# Work Order ID 66719

Item Name: Basket Hoop

DRAWING NO. D3166	TITLE BASKET HOOP	REV.A1	DART AEROSPACE LTD ENGINEERING ORDER		D.E.O. NO. D3166-A-2	SHEET NO. 1 OF 1	SCALE NTS
DRAWN AJS	CHECKED	MFG. APPR.	APPROVED		DE APPR.		
DATE 08.12.11	DATE 08.12.15	DATE 08/12/15	DATE 08/12/16		DATE 08.12.16

**D3166-1 BASKET HOOP**

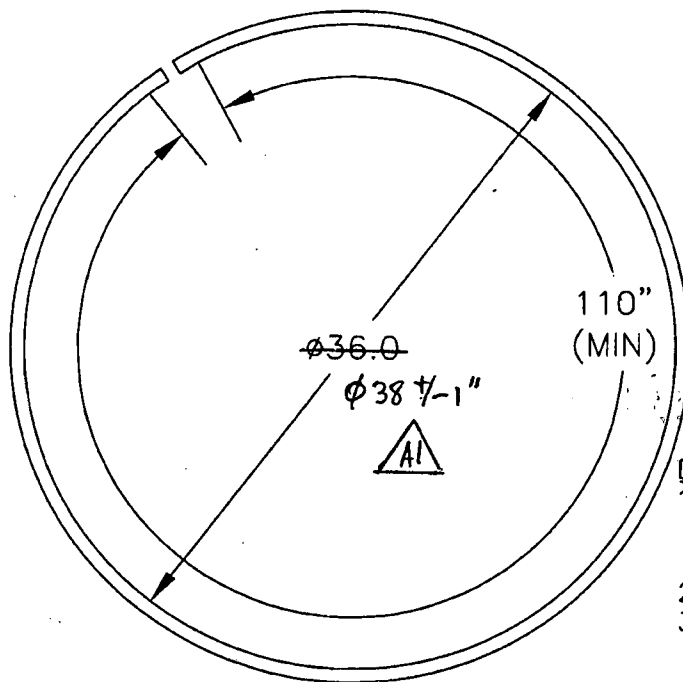
1) MODIFY MATERIAL NOTE FOR D3166-1 AS SHOWN:

WAS:

1) MATERIAL: AISI 304/316 SS SQUARE TUBING,  
0.75" x 0.75" x 0.063 WALL, 60.00" LONG  
(REF DART SPEC. M304TS0.750W.063)

IS:

1) MATERIAL: AISI 304/316 SS, 3/4 X 3/4 X 0.065 WALL SQUARE TUBING,  
60.00" LONG  
REF. DART SPEC M304TS0.750W.065
